CALVERT CLIFFS
NUCLEAR POWER PLANT

SUBJECT: Calvert Cliffs Nuclear Power Plant
Unit Nos. 1 & 2; Docket Nos. 50-317 & 50-318
Response to Request for Additional Information, Re: Calvert Cliffs Relief
Request RR-ISI-04-08 (TAC Nos. MF0568 and MF0569)

RELIEF REQUEST RR-ISI-04-08

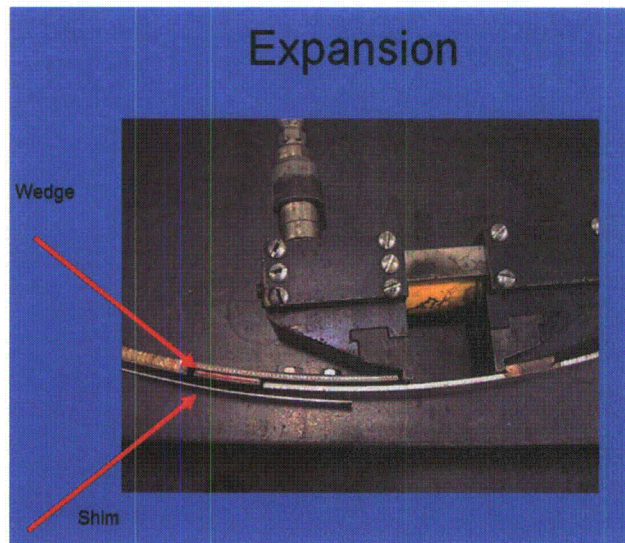
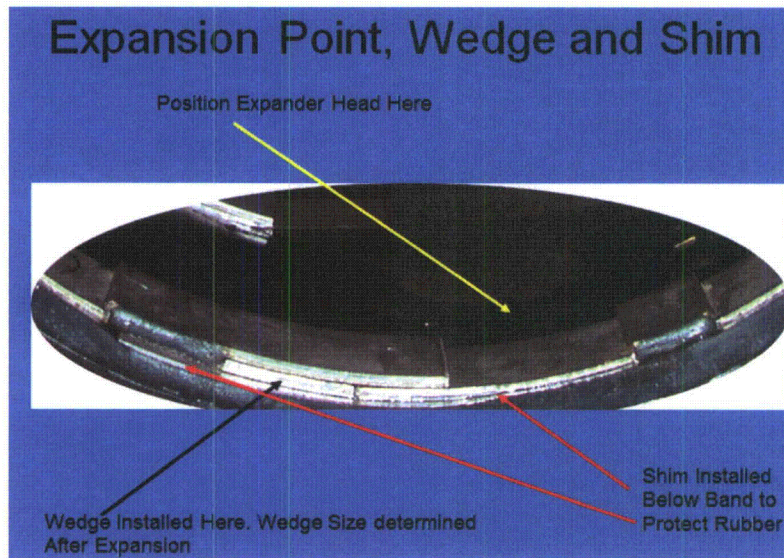
Provide a detailed description of the sleeve installation, including pre-installation inspection and preparation, installation, post-installation inspection, and acceptance criteria for the installation. (2) On page 4 of the RR the licensee stated that retaining bands are held in place by wedges. The drawing on page 2 of Attachment A to Enclosure 1 show the cross section of the wedge, push tabs and retaining band

but it is not clear how the wedge or push tabs hold down the retaining band. Provide a sketch of the wedge and how the wedge holds down the retaining bands. (3) The licensee stated that the retaining bands are expanded against the inside surface of the pipe. Clarify whether it is the expansion of the retaining bands or wedges that assist the retaining band in holding the gasket in place. (4) The drawing on page 2 of Attachment A shows a shim. However, the shim was not discussed on page 4 of the RR. Discuss how the shim is installed and whether it supports any loading. (5) Confirm that the backing plate will not be hydraulically expanded against the pipe wall. Does the backing plate support any loading? (6) The drawing on page 3 of Attachment A to Enclosure 1 is illegible. Provide a legible drawing.

- (1) An installation procedure is contained in Enclosure 1 that includes pre-installation, inspection, and post installation inspection. Note this procedure does not specifically call out the placement of the thin rubber gasket between the backing plate and the exposed ductile iron pipe surface.
- (2) See the figures below for specifics on the wedge details and expansion process.

- (3) The retaining bands are expanded as shown above. As the retaining bands expand they exert pressure on the EPDM rubber sleeve and create a leak tight seal against the pipe surface. Once the expansion pressure has been achieved within the acceptable range a wedge is placed into the gap between the push tabs and above the shim plate and the pressure is released from the hydraulic expander. It should be noted that a series of different width wedges are available to the installer to ensure as close as possible fit in the available space. This ensures that the expansion pressure applied to the retaining band is maintained within the acceptable range.

- (4) The shim is installed under the retaining band, below the wedge and is located to protect the EPDM sleeve from the slight motions imparted during the expansion of the retaining band prior to the installation of the wedge.

- (5) The backing plate will not be hydraulically expanded. The EPDM sleeve is placed over the backing plate. Then the two inner retaining bands are expanded to keep the backing plate in place.

FIGURE 1

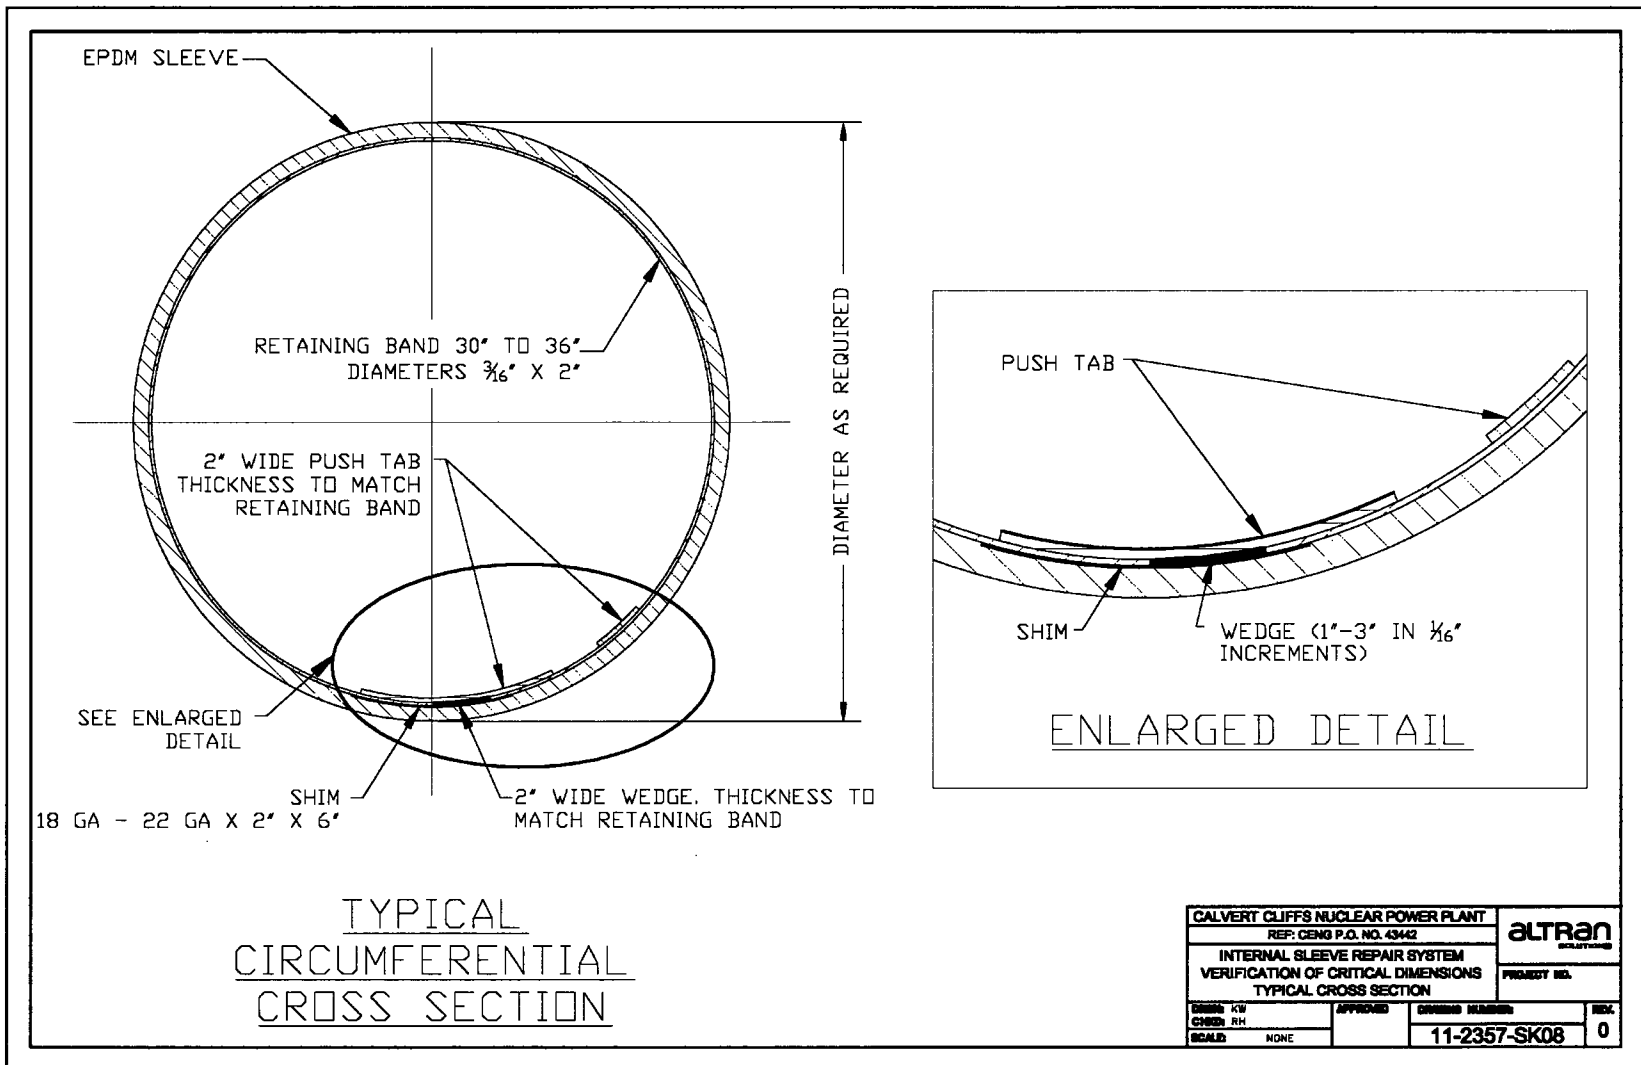
The licensee's calculation in Enclosure 1 to the RR showed that the retaining band thickness is 0.1875 inches. The backing plate thickness is 0.0598 inches. The gasket thickness is 0.3 inches. Provide the thickness of the cement liner, wedge, and shim. Provide the final cross sectional height (thickness) of the sleeve assembly.

The maximum cross sectional height will be 0.7826 inches and is located in the area of the push tabs. The typical cross sectional height is 0.5473 inches around most of the circumference of the sleeve assembly (see Figure 1). It should be noted that the grout liner will be removed from the area of the sleeve installation; therefore the projection of the assembly into the flow will be approximately 0.5326 inches (max) and 0.2973 inches (typical) when accounting for the removal of the 0.25 inch concrete liner.

- (6) Figure 1 is provided showing a circumferential cross-section of the mechanical sleeve assembly.
